01261-01378 Version 2

Safety Recall: Headlight LED Lens Film Delaminates

Supersedes 14-051, dated December 12, 2014, to revise the information highlighted in **yellow**

NEW IMAGE

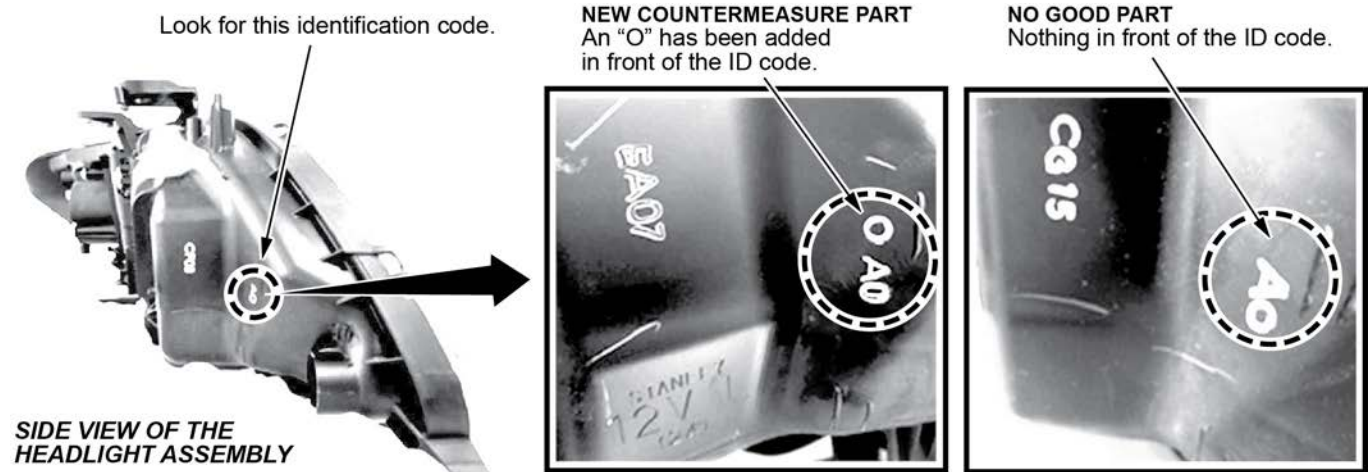
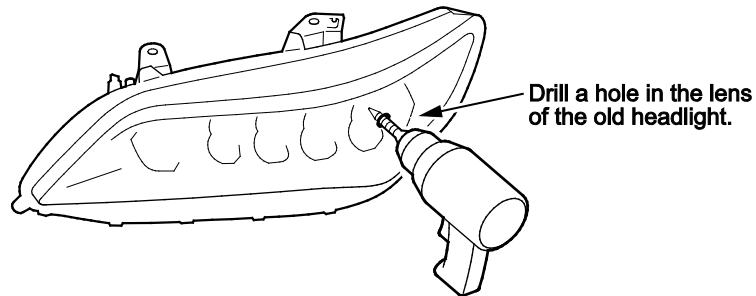
Under REPAIR PROCEDURE, information was added to identify the original versus improved part.

NOTE: To differentiate the original head light assemblies from the improved ones, the improved assemblies have the letter "O" in front of the ID code.
